# 2022-02-04 UPDATE

This first part of this document contains a quick comparison between the 2022-02-04 version of the model and the 2021-11-10 version of the model.

Figure 1: Daily Total Volume Difference v8.3.2 2022-02-04 vs v8.3.2 2021-11-10.

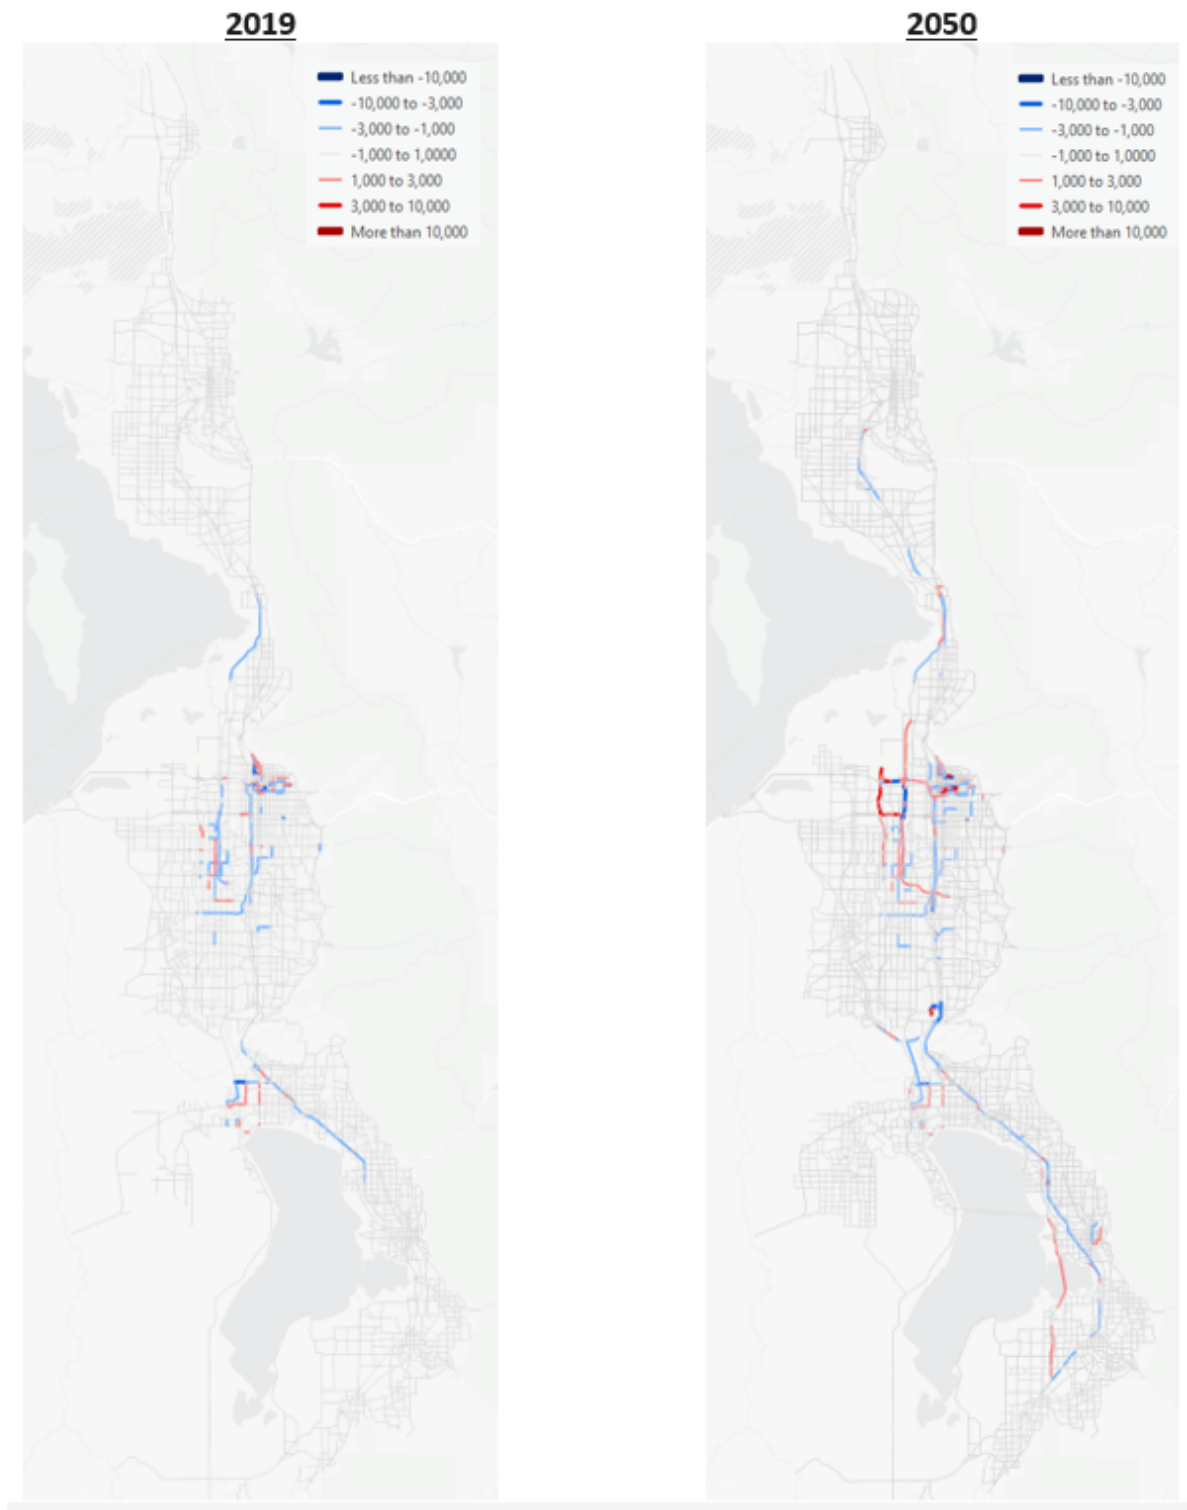
Figure 1 and Figure 2 contain a daily total volume comparison and a daily truck volume comparison. Daily total volumes are very similar between the two models. There is a slight shift of volume off of I-15 and onto parallel corridors. The largest volume shifts in 2050 are between I-215 and Bangerter Highway. Figure 1 shows one-way volumes.

Figure 2: Daily Truck Volume Difference v8.3.2 2022-02-04 vs v8.3.2 2021-11-10.

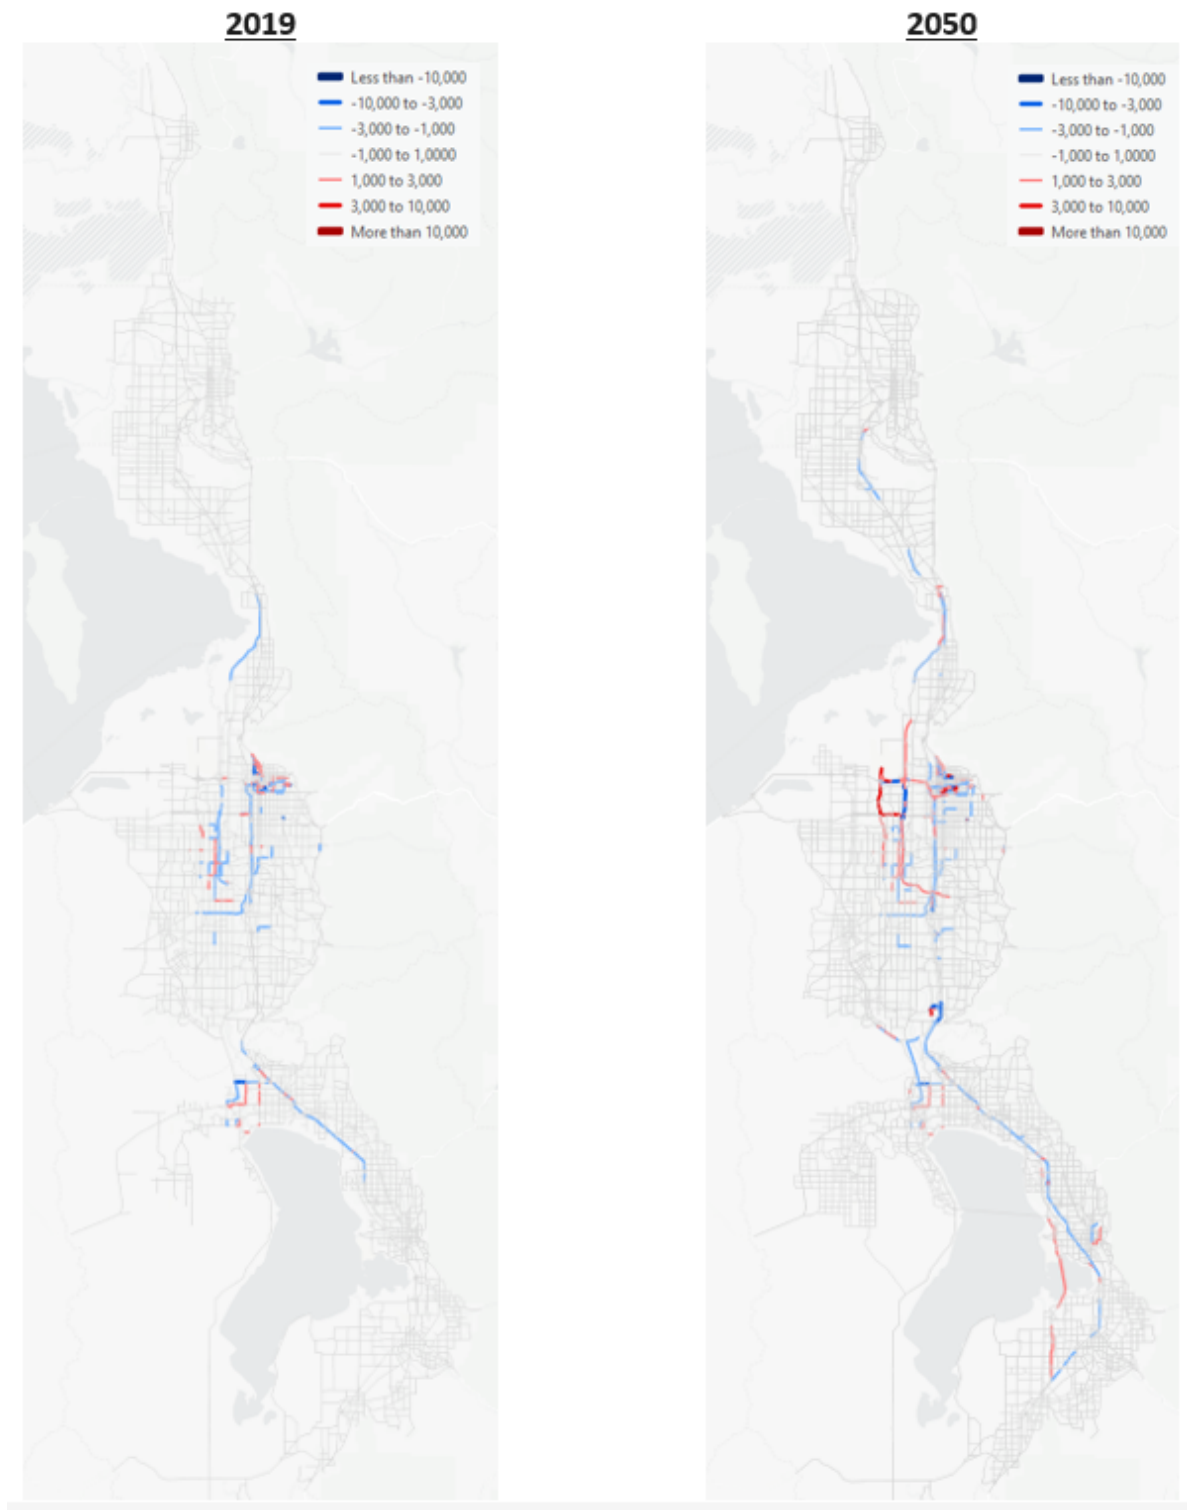
Daily truck volumes show more differences with volumes dropping between the two models. The drop in volumes is less than a 1,500 trucks per day on freeways but is widespread throughout the region. Figure 2 shows one-way volumes.
